### Addendum No. 3

## City of Coquitlam Tender 87422 Foster Pump Station Upgrades

Issue Date: May 23, 2023

**E** HEAT PUMP PAD DETAIL

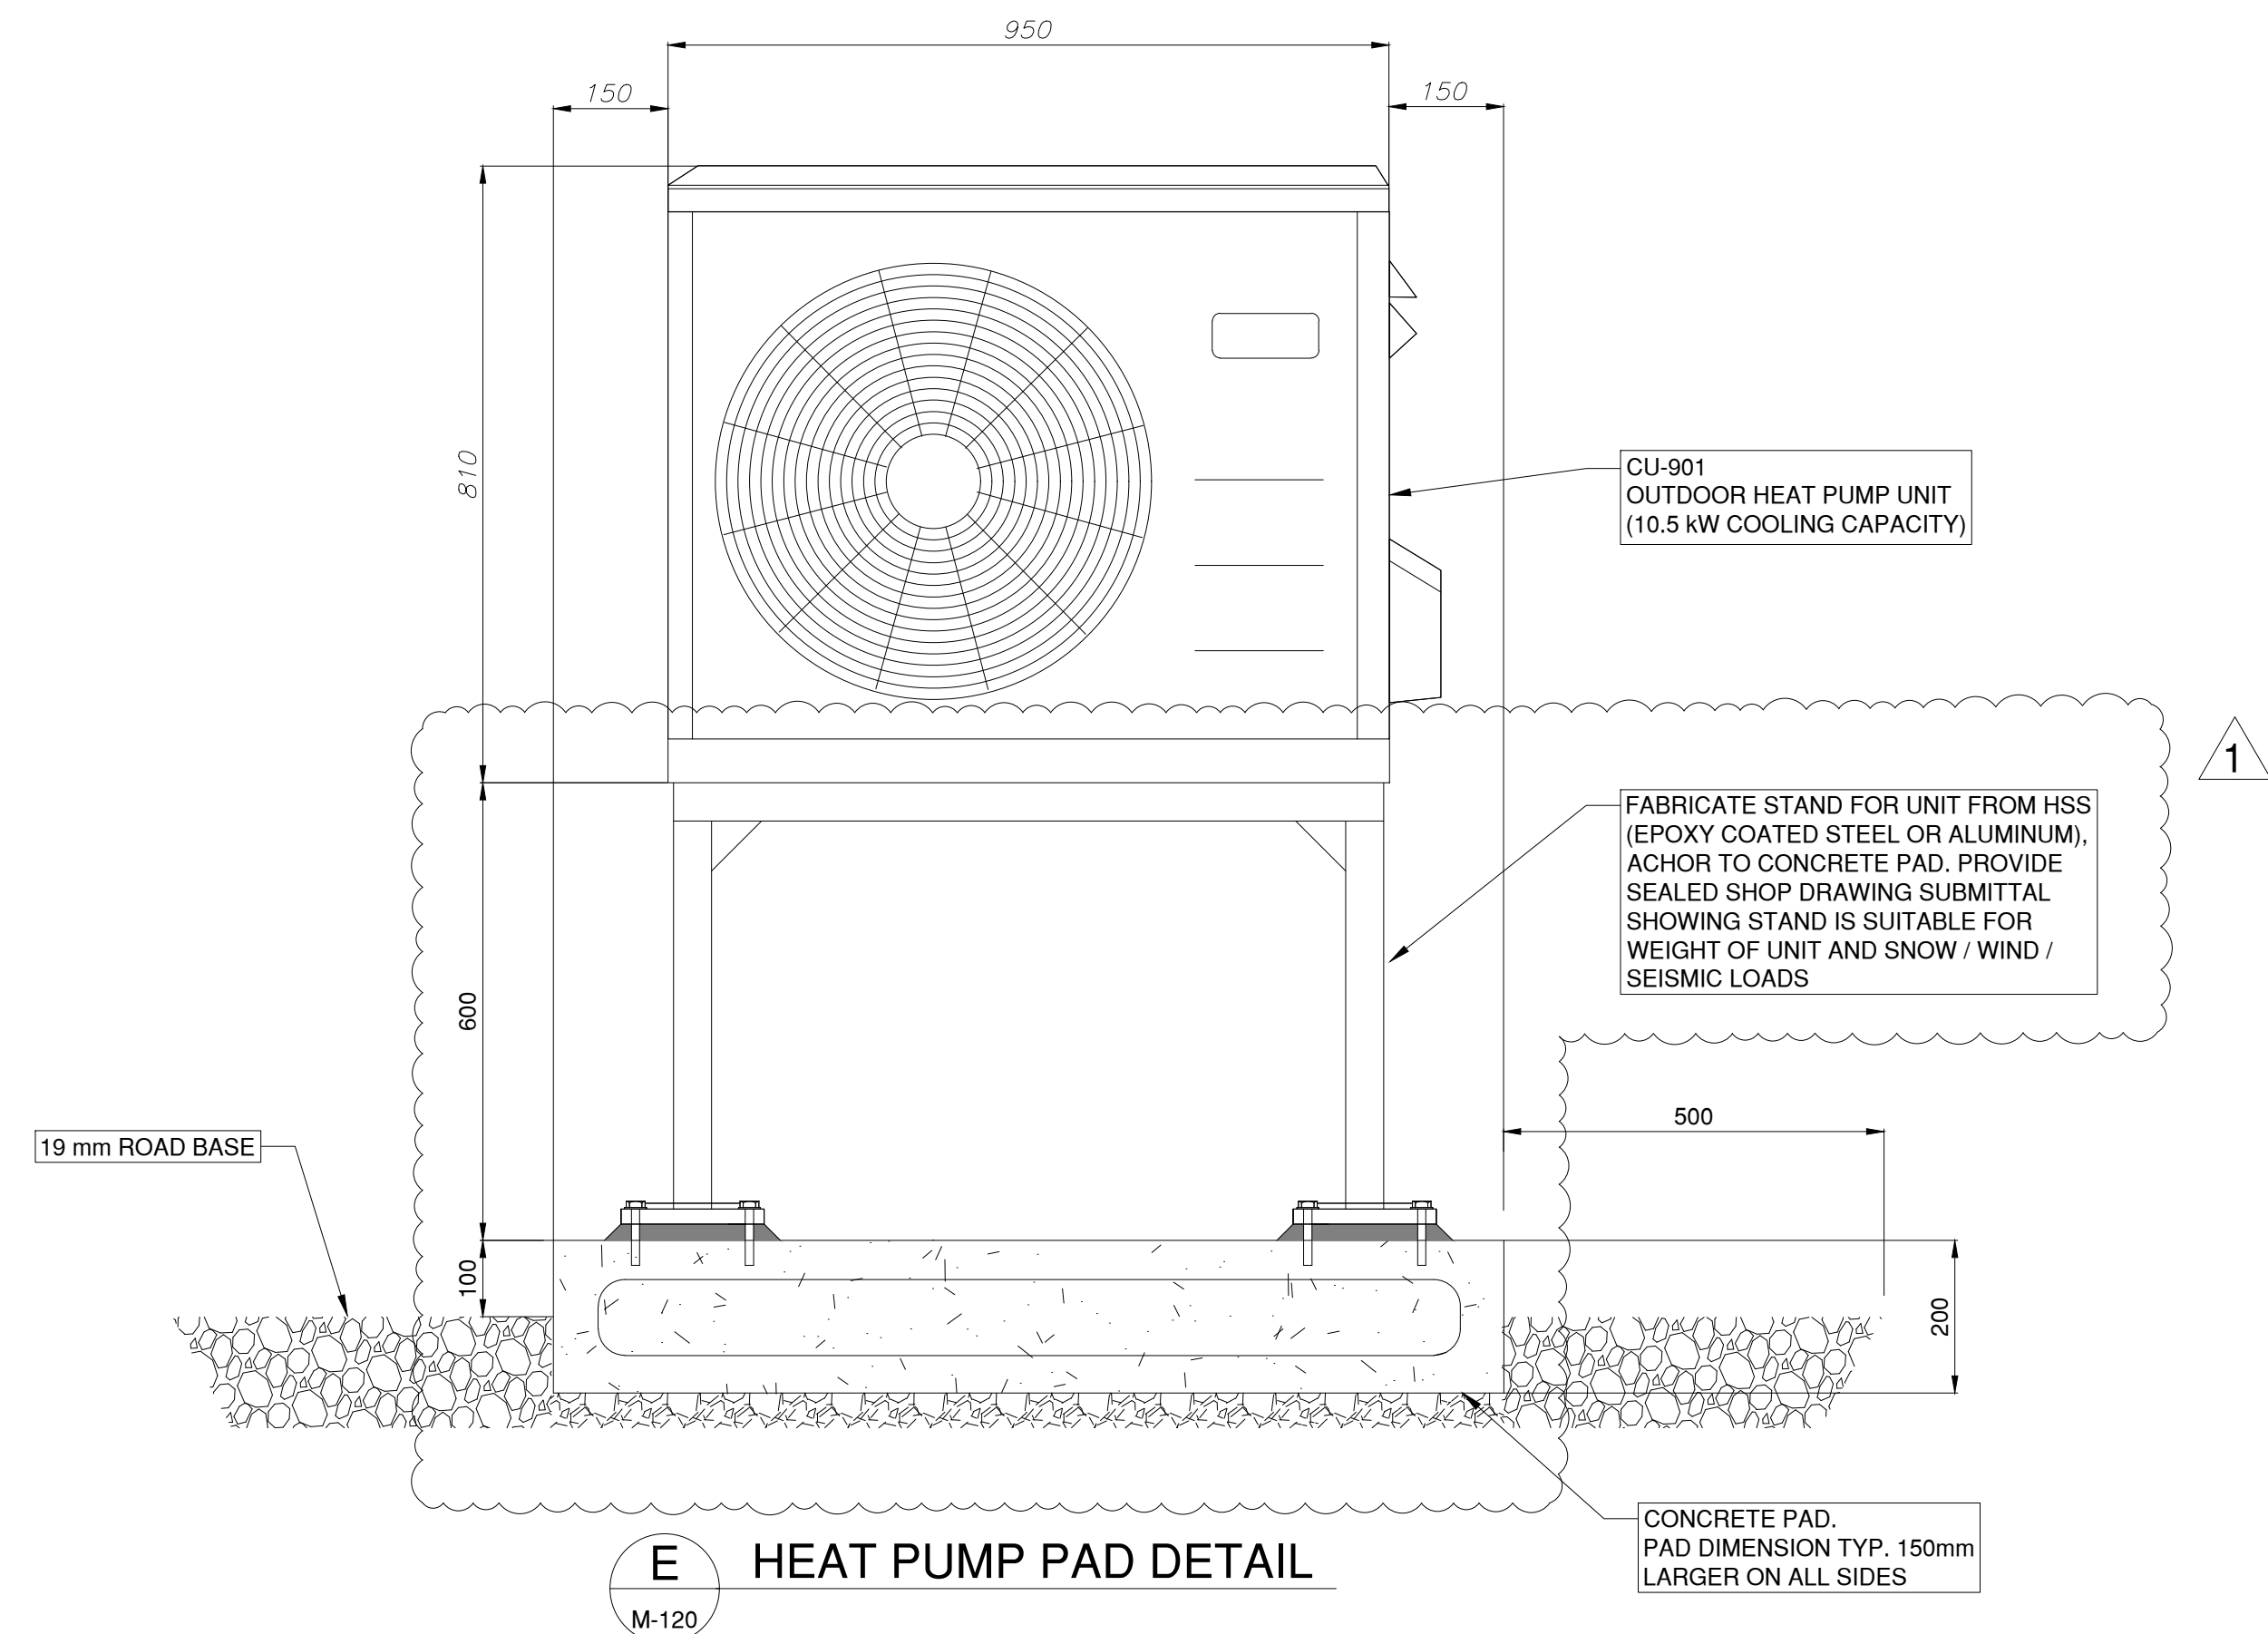
- Q11) Is an AC unit stand required for snow protection?
- A11) Detail E on drawing M121 is revised to include a fabricated heat pump unit stand and revised concrete pad thickness.**

1	12-MAY-2023	KL	ADDED HEAT PUMP STAND
0	05-APR-2023	KL	ISSUED FOR TENDER
No.	Date	By	Revisions
